## STERLING RANCH EAST FILING 7 REZONE

### LETTER OF INTENT

SEPTEMBER 2024

# V1\_Letter of Intent comments.pdf Markup Summary

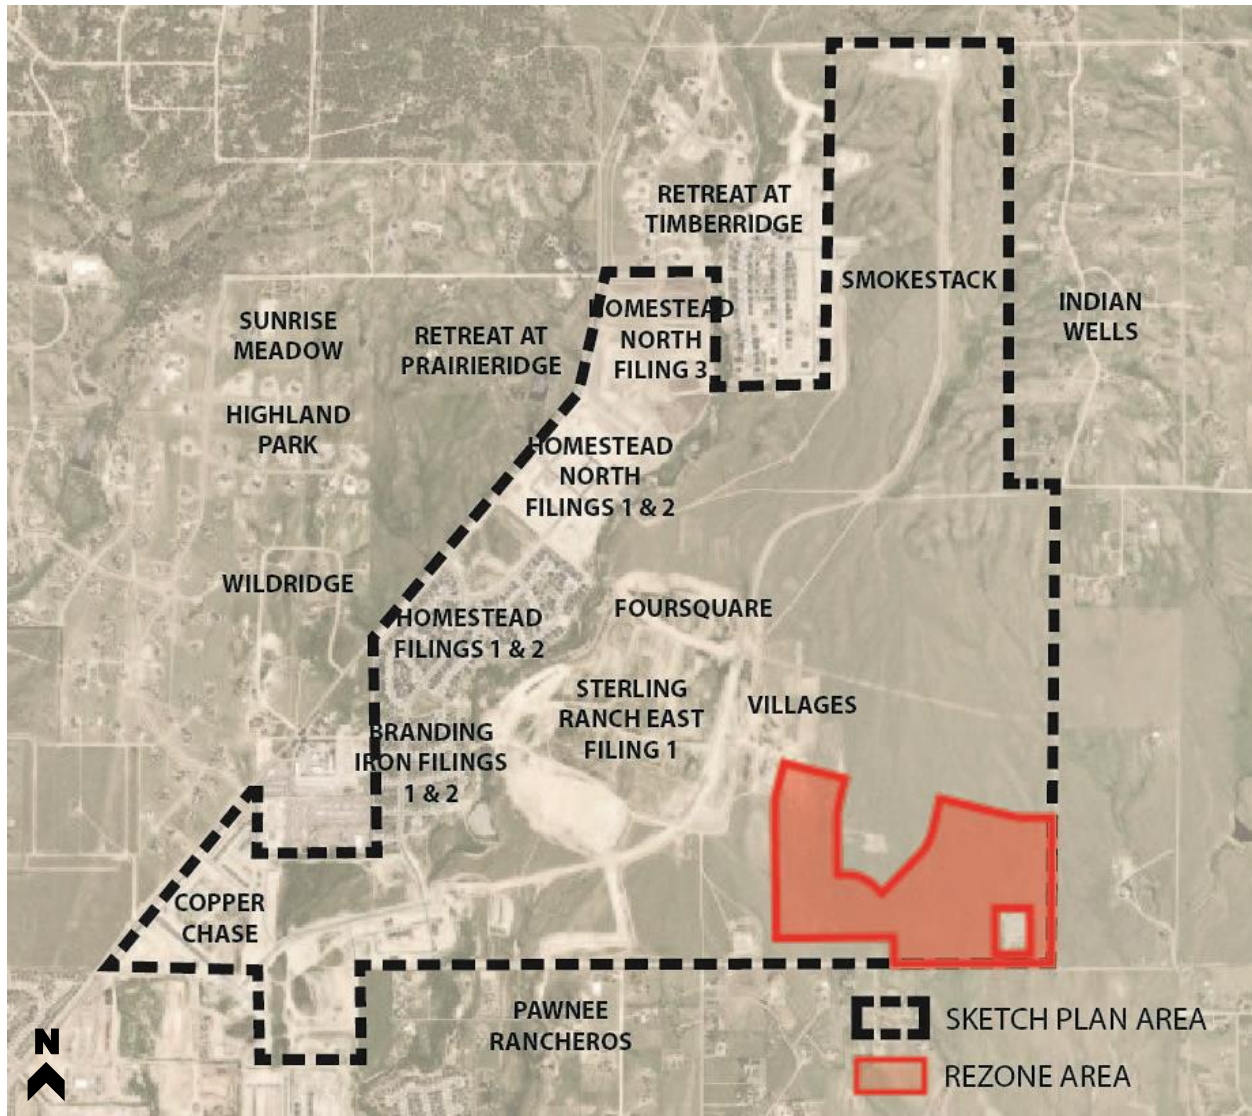
I thought it was now  
City Percheron?

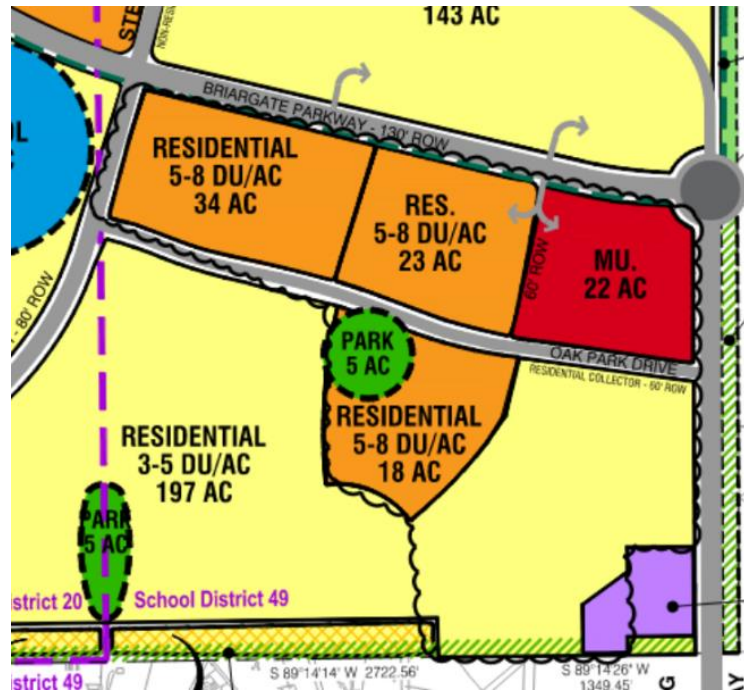
use the SKP in review  
now- it should be  
approved by 11/14
